**SUBJECT:** Throttle cable and Carburettor on **ECHO SRM-420ES, SRM-420TES, shindaiwa B410S and B410TS**

Number: Y2016-xxx  
 Issued: May 31, 2016

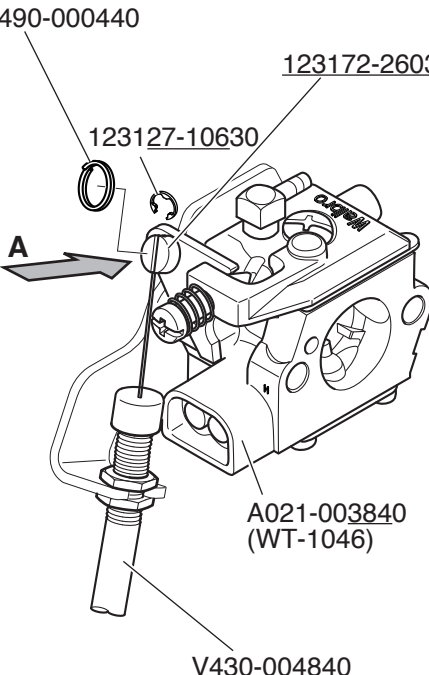
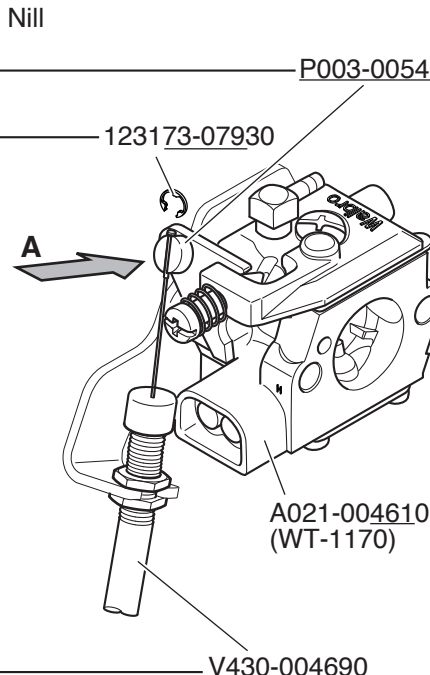
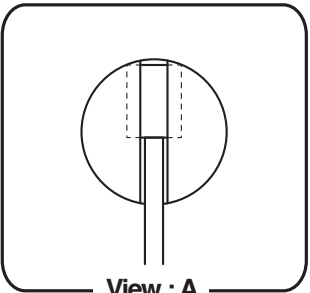
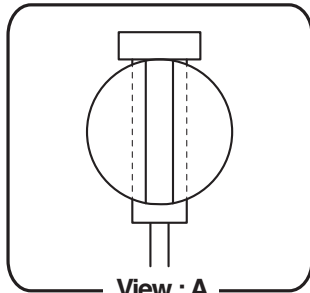
To improve strength, changed Throttle cable and Swivel.

<b>SRM-420ES(37)*</b>	Serial Number 37012860 and before	Serial Number 37012861 and after
<b>SRM-420TES(37)*</b>	Serial Number 37007730 and before	Serial Number 37007731 and after
<b>B410S(37)</b>	Serial Number 37002451 and before	Serial Number 37002452 and after
<b>B410TS(37)</b>	Serial Number 37001300 and before	From the next production
Clip	V490-000440	Nil
Swivel	123172-26030	P003-005460
Ring spring	123127-10630	123173-07930
Carburettor	A021-003840 (WT-1046)	A021-004610 (WT-1170)
Throttle cable	V430-004840	V430-004690
Throttle cable KIT		P021-XXXXXX

Swivel P003-005460 and Throttle cable V430-004690 can be used on the unit before this change. Throttle cable V430-004690 can be replaced with Throttle cable KIT P021-XXXXXX.
